Memo

Subject: Formal SRK Responses to KIA Requests

SRK has prepared this memo in response to questions and comments by the Kitikmeot Inuit Association (KIA) on the "Hope Bay Doris North Waste Rock and Ore Management Plan" dated December 2010. The original comments by KIA and SRKs responses are provided below.

Figure 1: Comparison of sulphur content for infrastructure samples with different amounts of visual pyrite

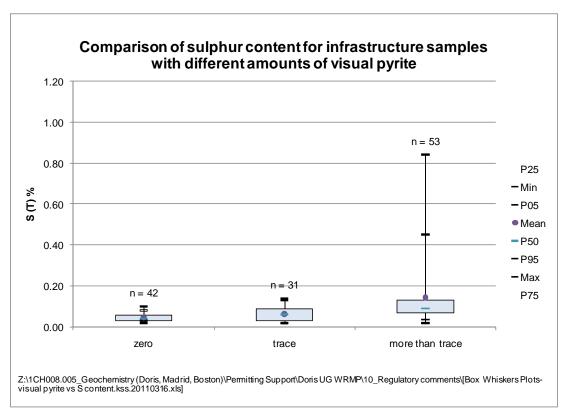
b: Visual inspection has been proposed as the primary screening method for segregating the waste rock into mineralized and non-mineralized storage areas on the pile. The inspection will include both rock type and sulphide content. The geologists have been further instructed to classify rock as "mineralized" if there are any doubts as to their ability to see or estimate the abundance of sulphides. However, HBML would like to emphasize that samples are also being collected at a minimum frequency of one sample per 5,000 tonnes for acid-base accounting (ABA) testing, with additional samples providing a sampling density of one sample per 1,000 tonnes for total inorganic carbon (TIC) and total sulphur content in units that have a higher degree of variability such as basalt or alteration zone material. The final destination of these materials in the dump is also being tracked so that the laboratory results can be directly tied to specific locations within the non-mineralized area of the pile.

The assumption that visual methods would be an appropriate means of segregating the rock is based on correlations between observations of sulphides in the geological logs and corresponding test results in data from recent construction characterization programs (SRK 2010a-d) in which the site geologists were asked to pay particular attention to the visual estimates. As shown in Figure 1, samples with higher sulphur values based on laboratory testing corresponded to observations of more than trace amounts of pyrite.

Figure 1: Critical Section of the Waste Rock Pile used in the Slope Stability Analysis

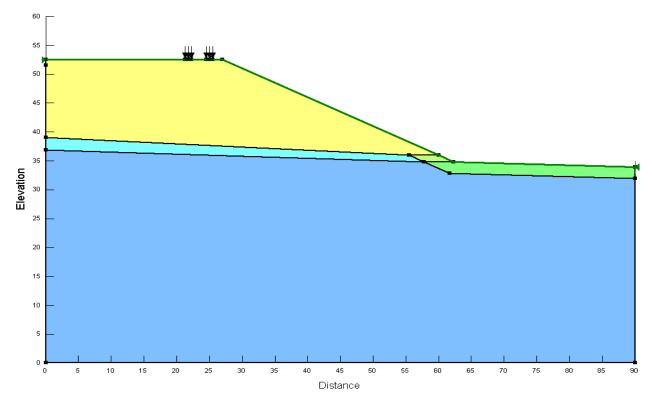
<u>KIA Question #2:</u> An estimate is requested regarding the maximum storage capacity of the waste rock pad based on maintaining stable slopes.

The storage capacities are based on an overall final slope angle of 2H:1V. A technical memo documenting the pile stability analysis for the 619,000 tonne pile configuration is provided in Attachment 2.

The analysis is carried out using a critical cross-section of the waste rock pile, taking into consideration the foundation slope and ultimate pile height. This typical section, complete with assigned material zones are presented in Figure 1 (note the overall slope angle is 2H:1V).
